| Model: AT-C2 | Date: 10-Sep-08 | No.: RD025001b |

| Subject: Firmware Release Note: Language Install | | Prepared by: T.Kiyohara | |

| Model: AT-C2 | Date: 16-Sep-08 | No.: RD025002h |

| Subject: Firmware Release Note: Engine | | Prepared by: Y.Urushihara | |

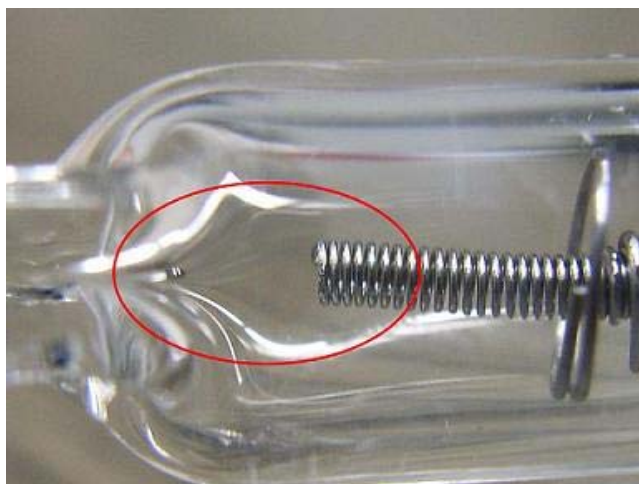
The heating roller fusing lamp (P/N AX440275) breaks, triggering SC552 or SC555.

- The fusing lamp control was modified so that the temperature conditions do not weaken the tungsten wire.
- Even after upgrading the firmware, the symptom may still occur if the wire has already been weakened enough.

Replace the fusing lamp and then upgrade the Engine firmware as described above.

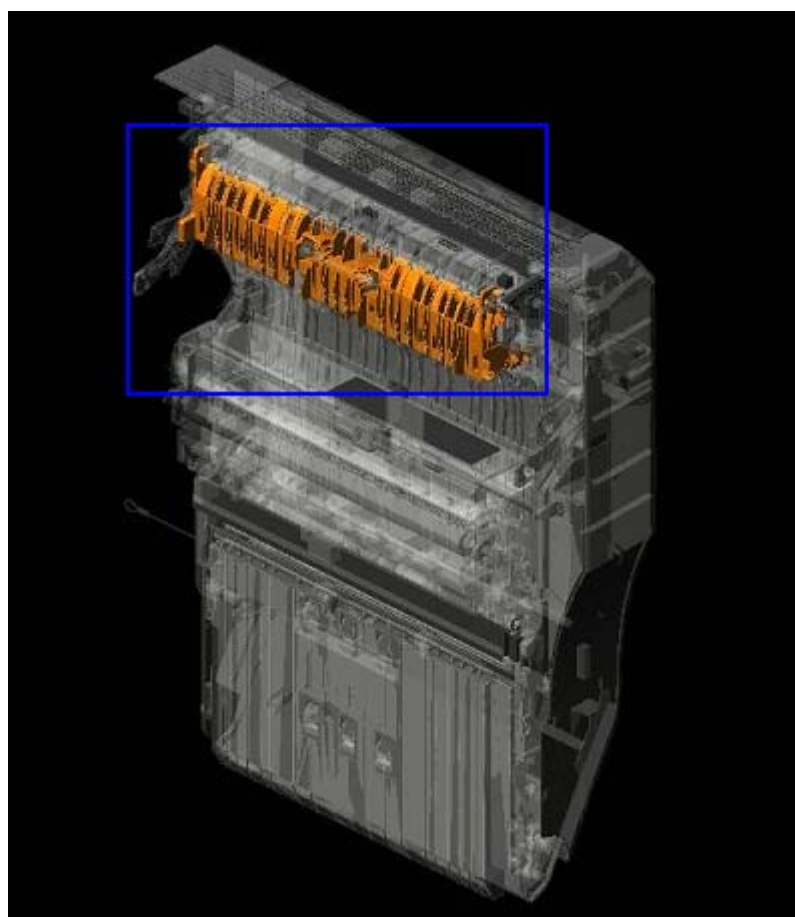
High temperature and a mechanical load cause the fusing entrance guide plate to bend.

Replace the guide plate with the new part shown below.

Change: A stay was added inside the guide plate.

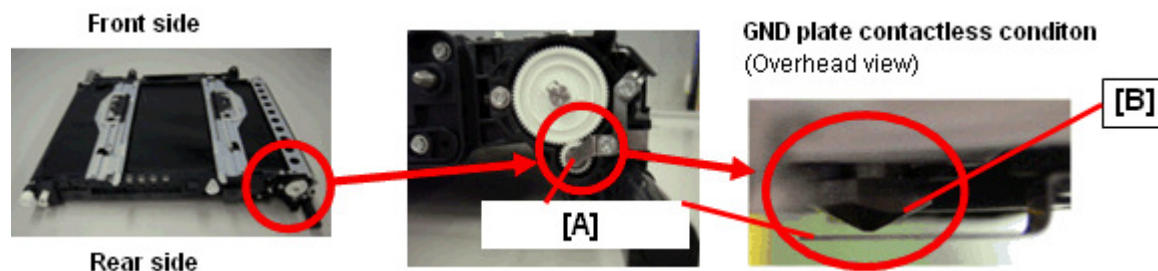
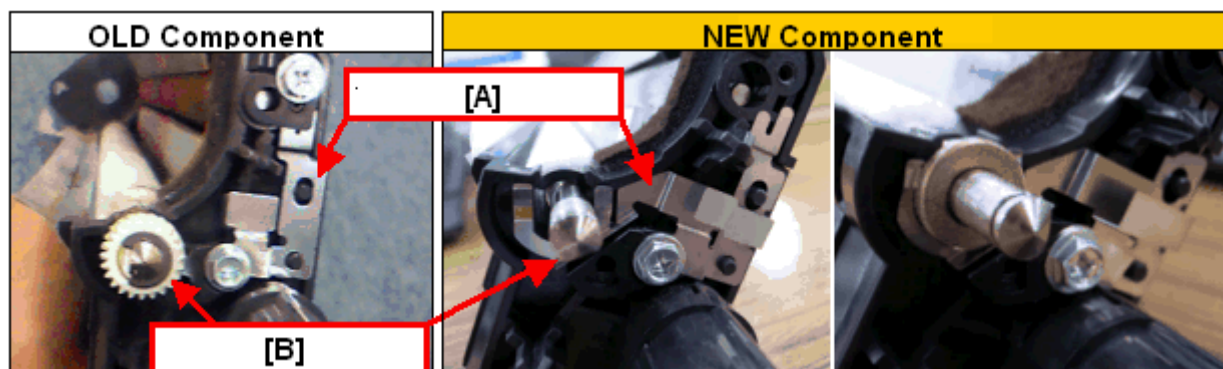
Sometimes, the GND plate at the rear side of the ITB cleaning unit [A] does not touch the lubrication application shaft [B]. As a result, a minor electrical leak occurs, which can trigger electrical noise. Sometimes, this effect appears as lines at 110mm intervals.

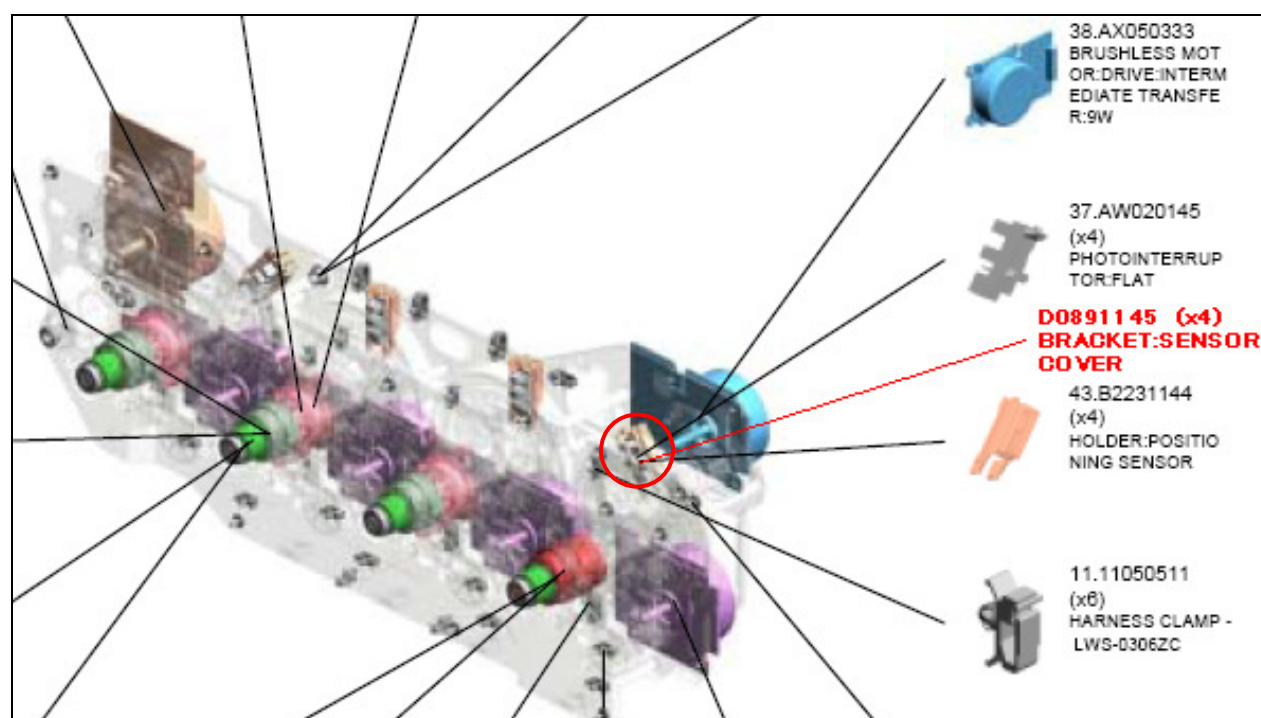
Change: *The phase control positioning sensor ass'y was added as a new part.*
 A sensor cover was added to the phase control positioning sensor.

Reason: To avoid electrostatic influence from drum gear.

Fig. 1

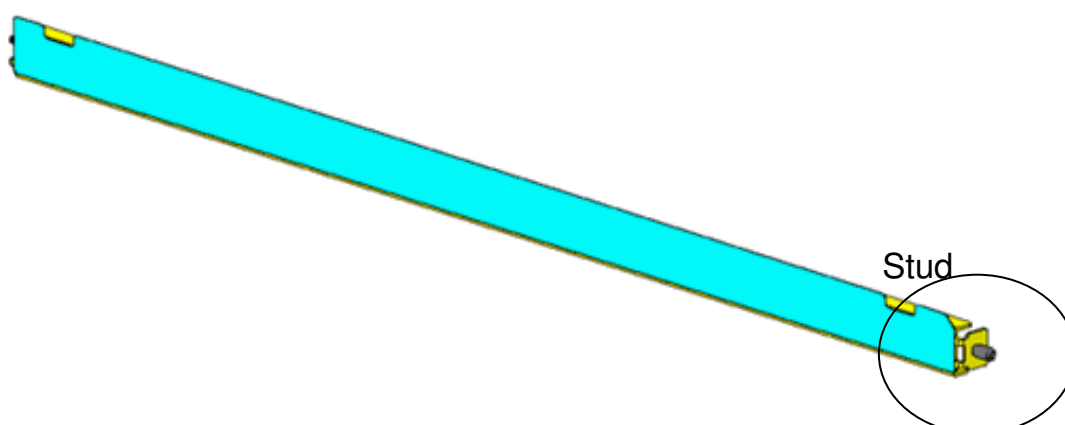
Reason: To prevent paper jams by minimizing the range of motion (twisting) of the stay.

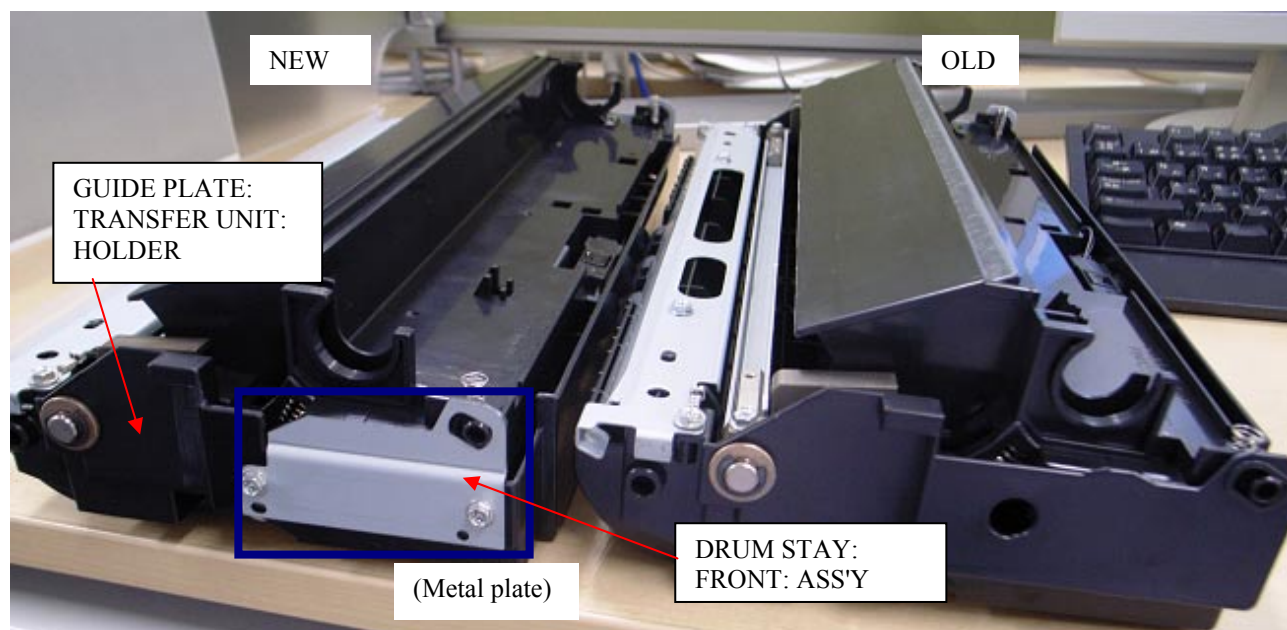
Reason: To further increase the load-bearing strength of the parts.

Important: Interchangeability is **X/O as a set** (all six parts together). *1: One from the two.
